Technical modifications and updatings of the spare parts catalogue coral 65 – 65 II – 85

Here below you will find the most important modifications carried out on above-mentioned machines. We ask you to carefully read all the information, necessary for your future orders. We add furthermore the first page, the summary and the updated index with all its revisions, so that you may easily verify which tables are missing in your files and ask for the missing copies. As you may note, we have added the missing tables of **coral 65 II** and **coral 85**, available on request.

0801-10 R04

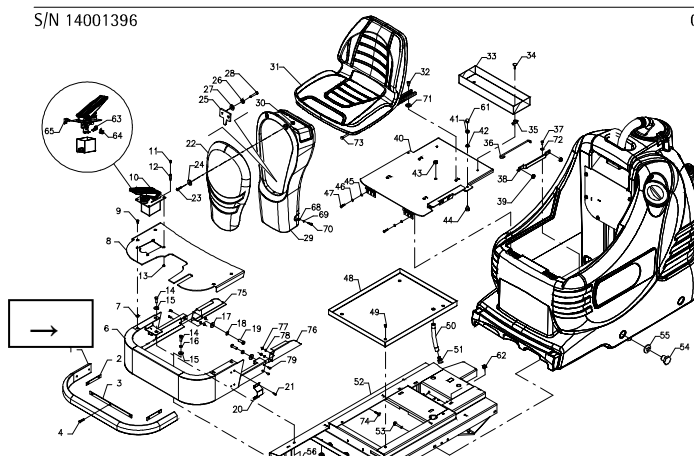
→ Starting from serial number: 14001396 dated 04/04/14 – table 0801-10 R04 – coral 65-coral 65II
In order that the bumper cover was supposed to be the front outer part in the different coral machines, different versions have been realized between the machines having disc brushes or cylindrical ones that differ in the rear part: for the disc brushes machines the two side protections are longer. It has been decided to adapt the cover applying for part number 20811010. For the disc brushes versions the two side covers will be added having part numbers 20811150 and 20811160 fixing them with black zinc-coated screws M5x12 (part No. 60100505).

For the spare parts management whenever an old cover with part number 20811070 or with part number 20811140 (for machines with dosing system) is requested, the assemblies are:

V0811020 cover complete for standard machine

V0811030 cover complete for machines equipped with dosing system

0801-10 R05

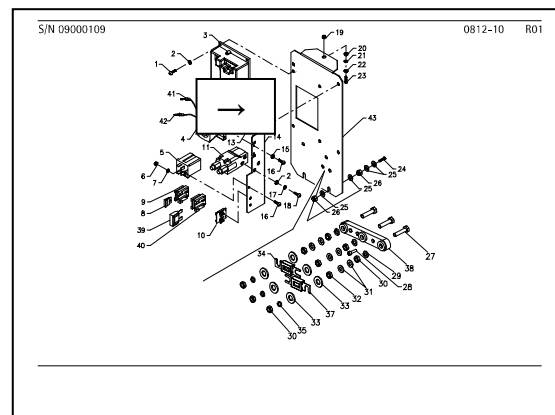
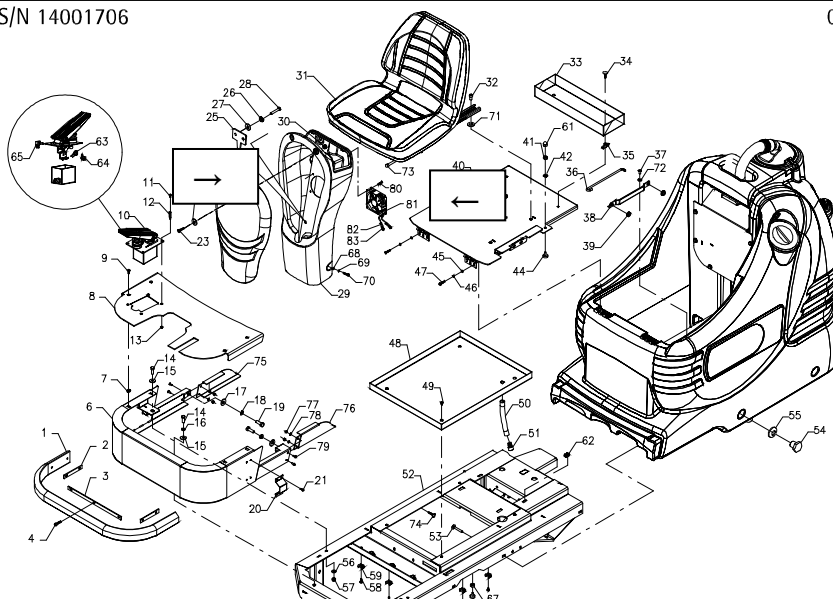
To improve the performances of the chopper card, we have added a cooling fan. This device requires the realization of ventilation openings on the front column, on the front frame and on the electric panel. The modification can be applied also on already produced machines. The complete assembly of the fan has part number: V0812010. The assembling instructions with No. T081208 are available.

0802-30 R00

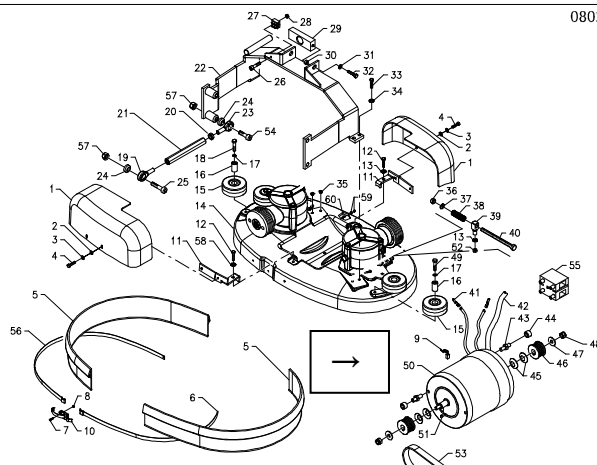
Ref. table 0802-30 R00 – coral 85 – pos. 50

The part number of the brushes motor has been corrected, namely: 46220200 Motor 24V – 900W

Ref. table 0803-10 R00

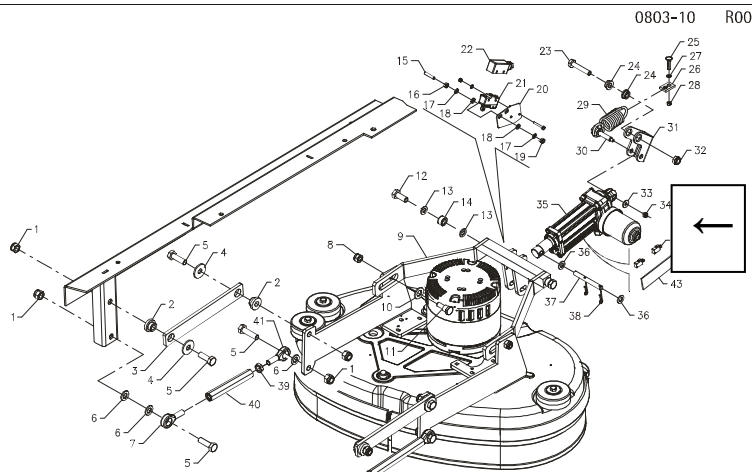
We have modified the drawing correcting mainly the design of the actuator.

Ref. table 0803-20 R01

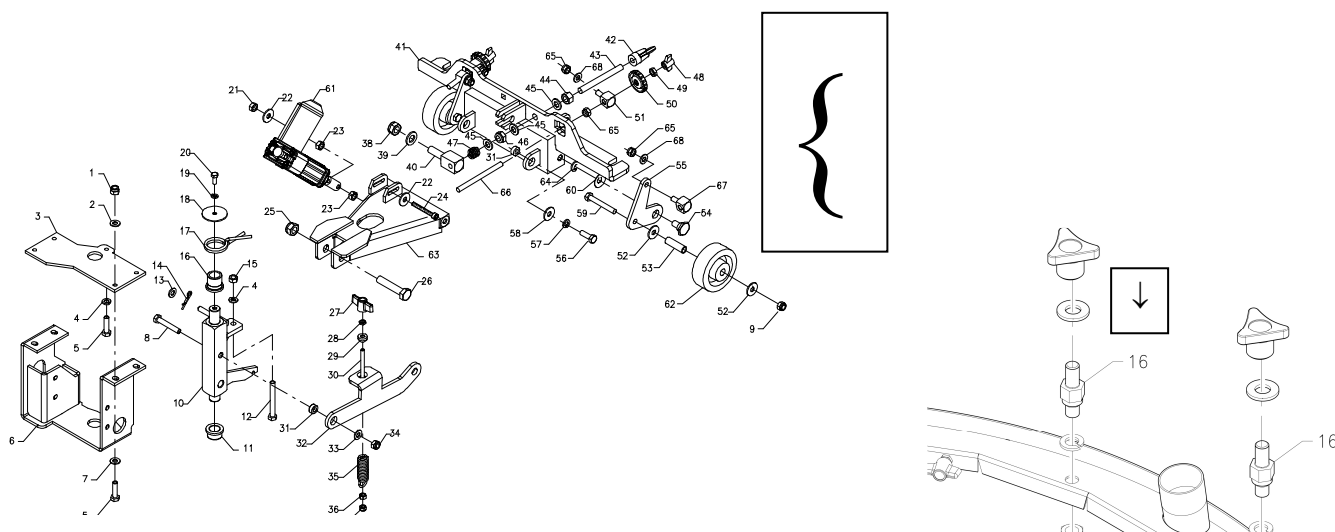
We have updated the table for the models coral 65 II and coral 85.

Ref. table 0807-10 R01

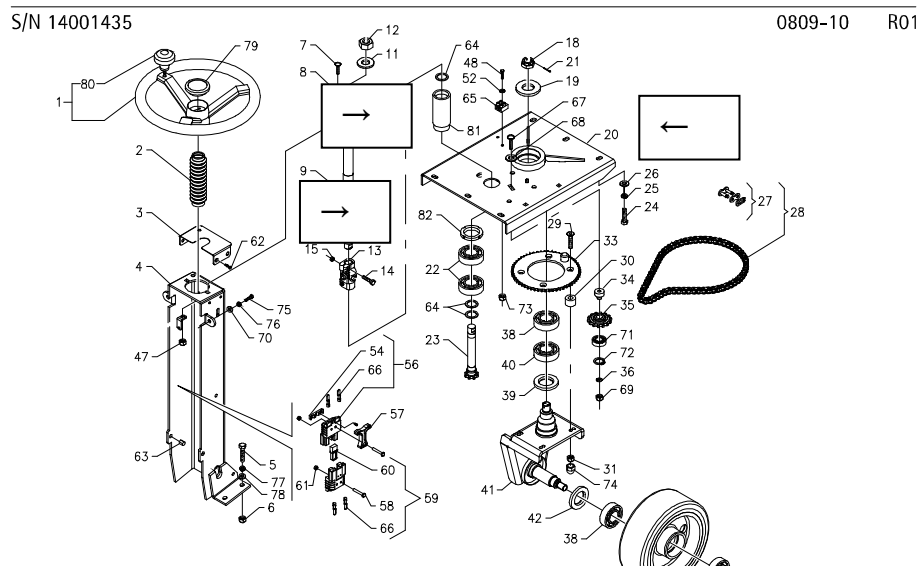
We have modified the drawing and the description of the brake blocks. We have furthermore corrected the part numbers of the positions 13 (geared motor) and 31 (geared motor assy).

On request it is possible to assemble a softer wheel (pos. 1) having part number 46524120. The wheel material is of 65sh, recommended for when the machine becomes slippery.

Ref. table 0810-30 R01

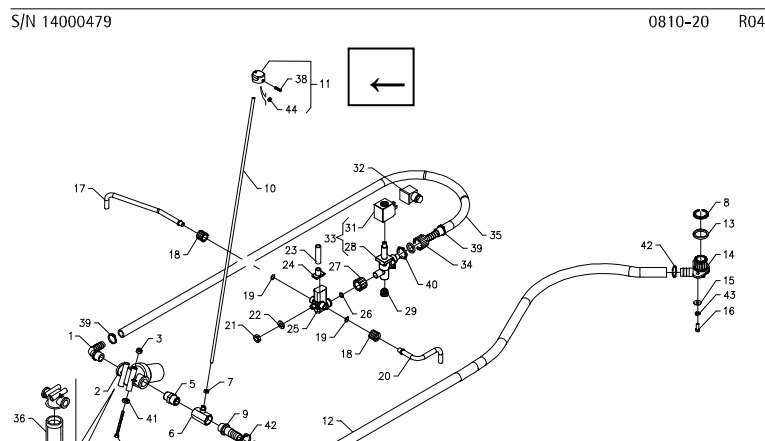
We have updated the descriptions of some hoses and replaced the clamp 61930011 with one having part number 61930012 clamp hose wrench (pos. 28).

→ Starting from serial number: 13003293 dated 02/10/13, table 0812-20 R04, pos. 5

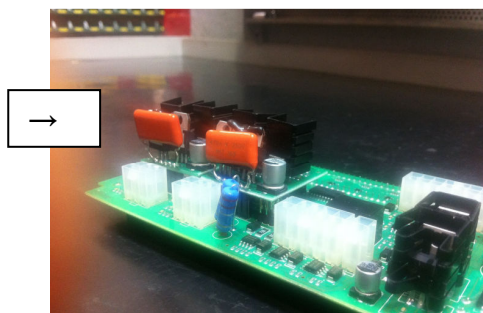
We have replaced the fuse 62801003 of 10A with one of 15A having part number 62801501. This fuse is assembled on the check card of the functions, pos. 5.

→ Starting from serial number: 14003023 dated 29/07/14 – table 0812-20 R05

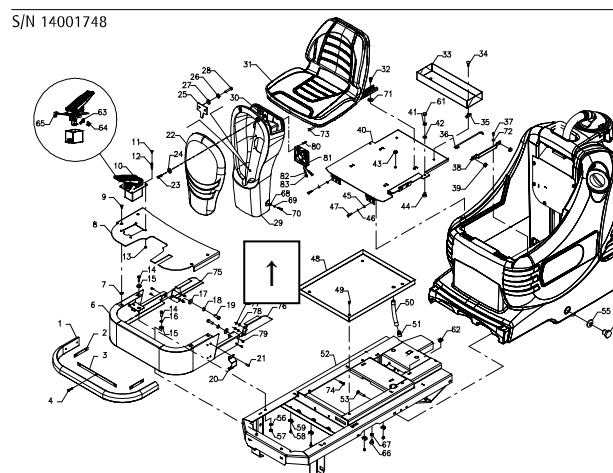
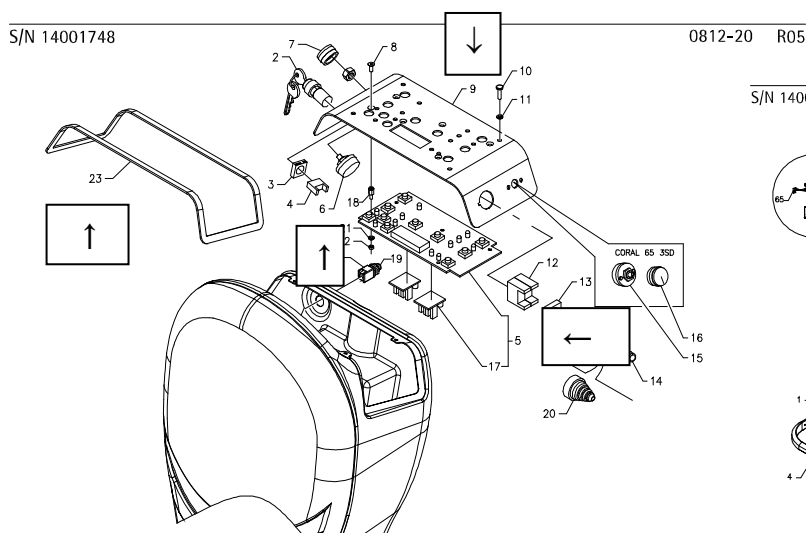
The shaft of the rotating commutator (pos. 6, cod. 63405002) with carve deformed the knob during the fixing with the result that it inclined itself. To avoid this problem we receive the commutators with the shaft without carve. The part number remains the same and it is interchangeable with the previous one.
